98-BCBOA-092-A

BOARD OF ADJUSTMENT AND ZONING APPEALS ACTION

5. Name of Development Cincinnati Airport Marriott Hotel in Skyport 275 Development.

STAFF REPORT

ENTRY SIGN

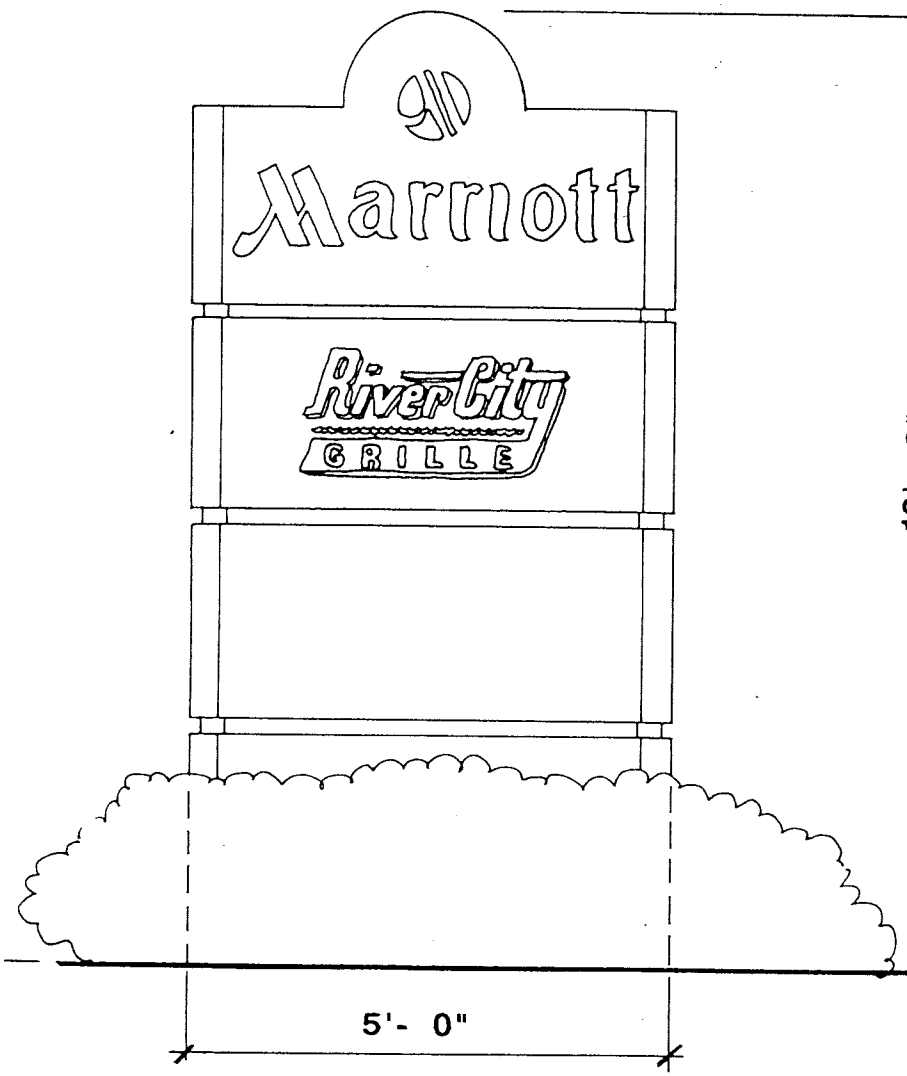
We believe that this redistribution of signage square footage is consistent with the intent of the sign ordinance, and is intended to compensate this 20 square foot increase in the directional restaurant entry sign with the down sizing of the hotel entry sign from 100 sq.ft. allowable to the 50 sq.ft. we are proposing. This increase in the height from 5'-0" to 6'-0" is due to the Marriott arch on top of the sign which gives the sign character and consistency with the hotel entry sign. The majority of the sign is below the 5'-0" height. We believe this integrates the signage on the site and the building to create an integrated and handsome sign package.

DIRECTIONAL RESTAURANT SIGN

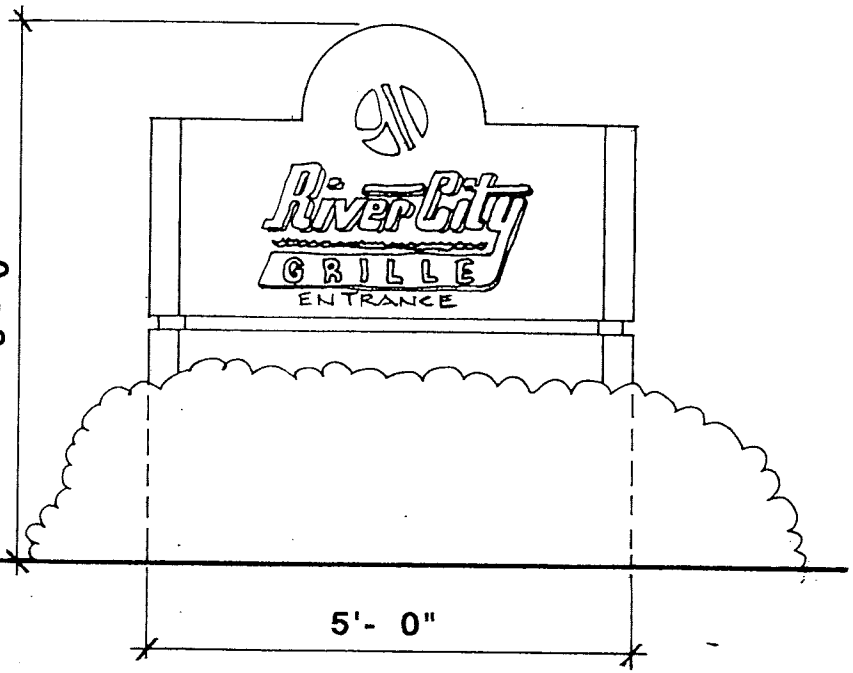
The applicant is proposing a directional sign at six feet in height and with a sign area of 30 square feet. The applicant is seeking a one foot variance of the height and a 24 square foot variance of the area of a directional sign.

1. The directional sign proposed by the applicant advertises a restaurant that will be located within the hotel. The location of this sign is within the parking lot near the building entrance to the restaurant and not near the intersection of Progress Drive and the entrance to the site. The directional sign proposed by the applicant is being used as a free standing monument sign within the site. The Boone County Zoning Regulations do not permit more than one free standing sign on an individual site. The purpose of directional signs is to direct automobile traffic where to turn off a road or street into a site. In this instance, if the sign is used for "directional purposes", the sign should be located near the Progress Drive/site entrance intersection where there will already be a free standing advertising the restaurant. An alternative is an attractive modestly sized building mounted sign near the entrance to the restaurant that would be permitted by the Boone County Zoning Regulations.

A variance is requested to increase the allowable square footage and height of the proposed directional restaurant sign from 10 sq.ft. to 30 sq.ft. and from 5'-0" high to 6'-0" high.

The following conditions will apply: (1) The variance for the sign of the front of the building be approved provided the building mounted sign on the west and east sides be restricted to no larger than what was presented at the meeting. (2). The Board moved to deny the variance on the Directional sign based on the definition of a directional sign in the Boone County Zoning Regulations Book.
